RE: 7-ZN-2016#2  
Palmeraie Phase II  
95T74 (Key Code)

The Planning & Development Services Division has completed the review of the above referenced development application submitted on 3/6/2019. The following **1<sup>st</sup> Review Comments** represent the review performed by our team, and is intended to provide you with guidance for compliance with city codes, policies, and guidelines related to this application.

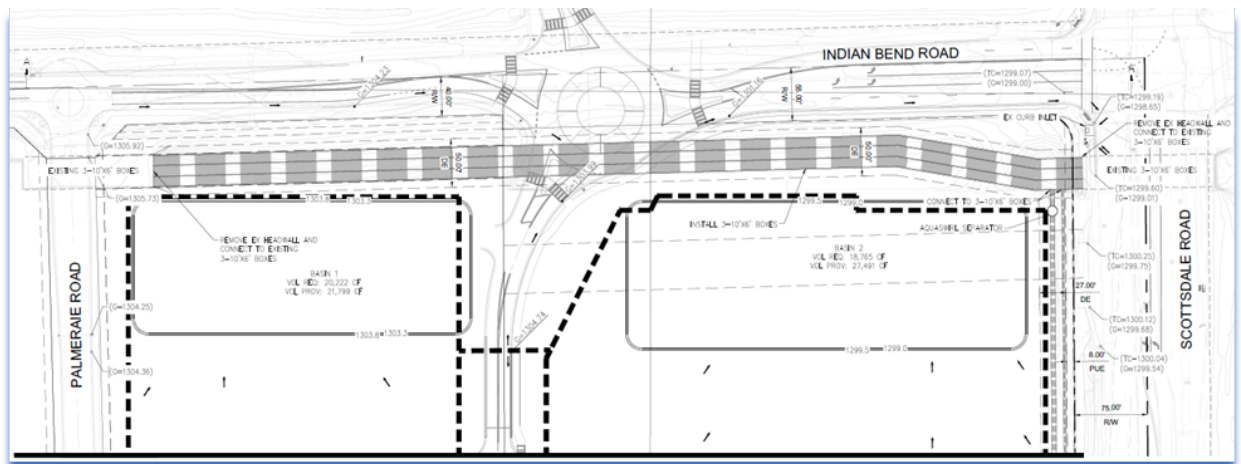
- j. Construction of two temporary stormwater storage basins on the proposed project site for Palmeraie Phase II was required as a part of the proposed improvements on the project site for Palmeraie Phase I (18-DR-2018) which can be seen in the below screenshot. These temporary stormwater storage basins also appear on the Construction Documents aka Civil Improvement Plans which has just been submitted to the City (PC #1184-19). Therefore, these temporary stormwater storage basins must be shown and label as “existing temporary stormwater storage basins” on the Preliminary G&D Plan for Palmeraie Phase II as appropriate. (DSPM, Sec. 4-1A)
